Addendum to Preferred Project Report

Rainbow Beach Concept Plan
MP 06_0085

St Vincent's Foundation Pty Ltd | 15 August 2011

Addendum Figure 1 Areas of open space/ biodiversity to be rezoned

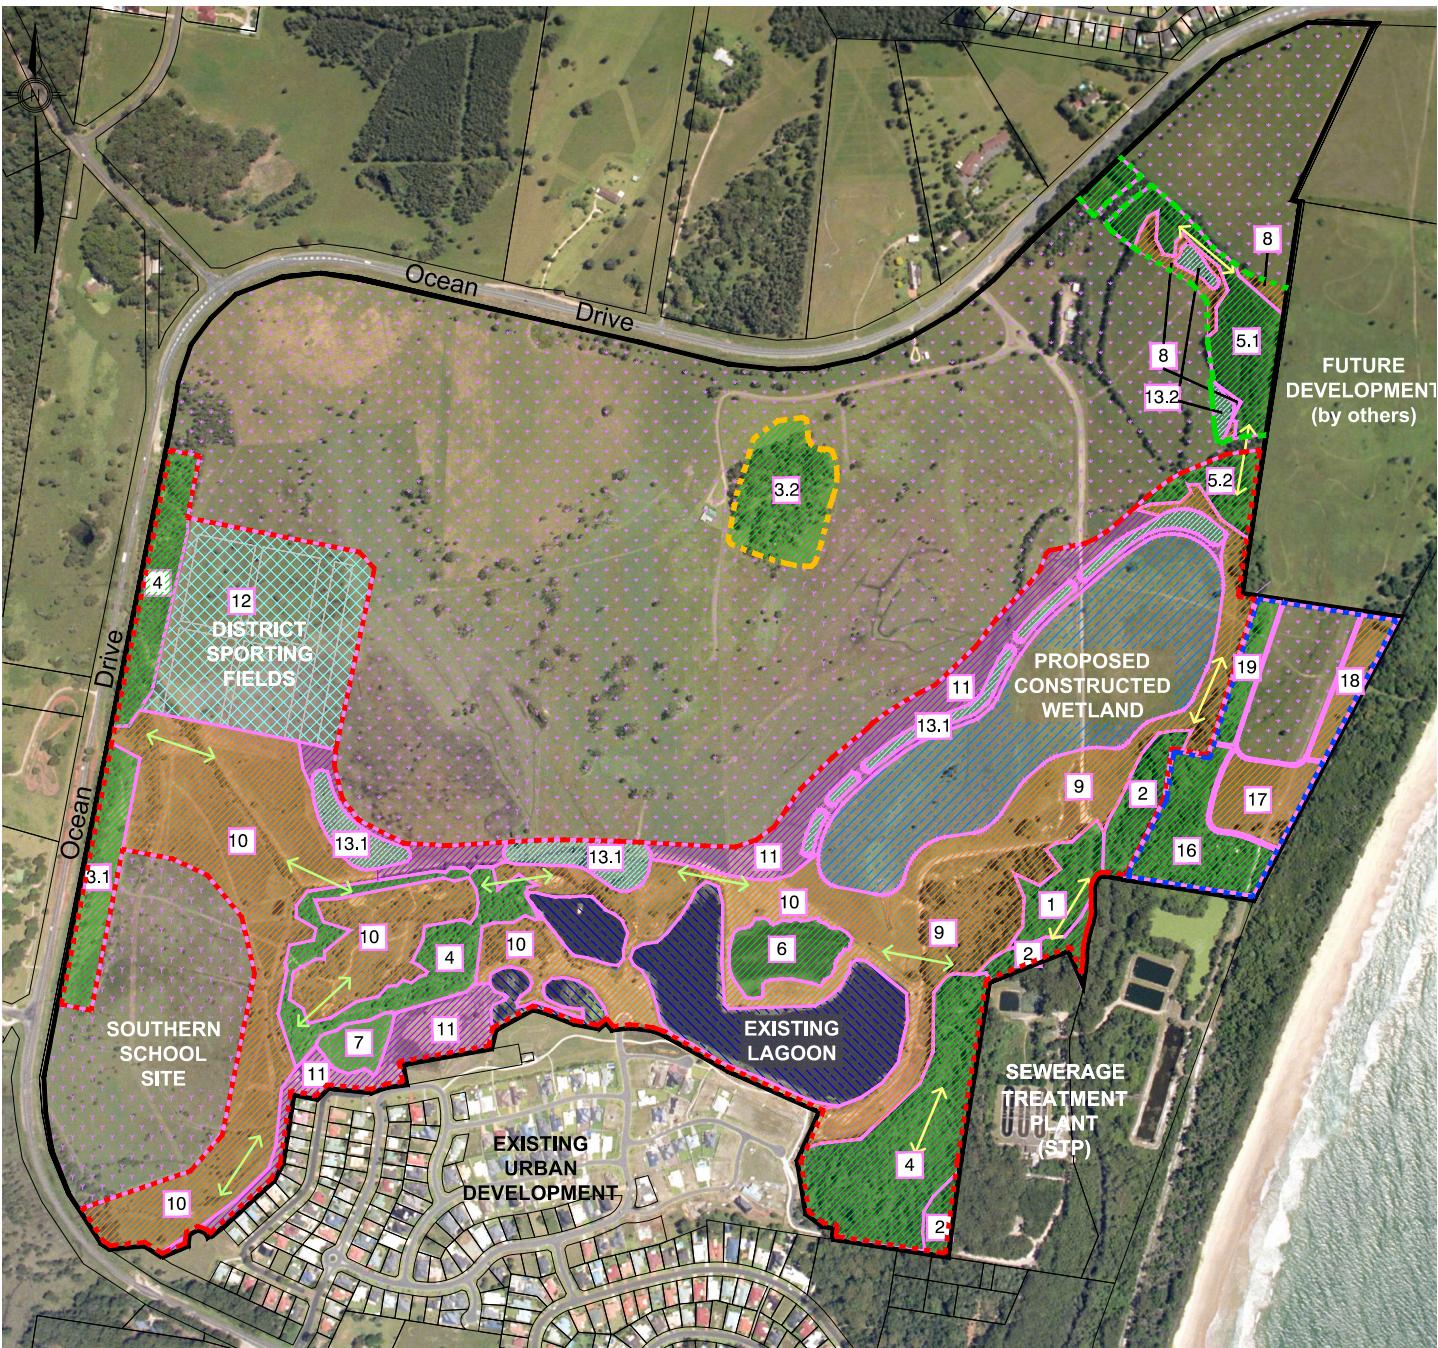
In response to a concern raised by the OEH in respect of the protection afforded to areas of biodiversity significance, an additional figure has been prepared (referred to as Addendum Figure 1) which illustrates areas to be the subject of a Planning Proposal by Council to establish suitable zonings (E2 or E3) over the relevant areas.

<p>All areas set aside for open space/ biodiversity will be protected by zoning provisions to be commenced by Council under a Planning Proposal following consent for the Concept Plan and the Project Application. The proponent has committed to support the Council in this action.</p> <p>These areas will be provided with a surrounding buffer to be created by adjacent streets and their verges in accordance with the Concept Plan.</p> <p>The stormwater management measures, the approach to landscape treatment within the development areas, and the vegetation management within each of the open space/ biodiversity areas enable appropriate levels of protection for the areas containing EECs.</p>
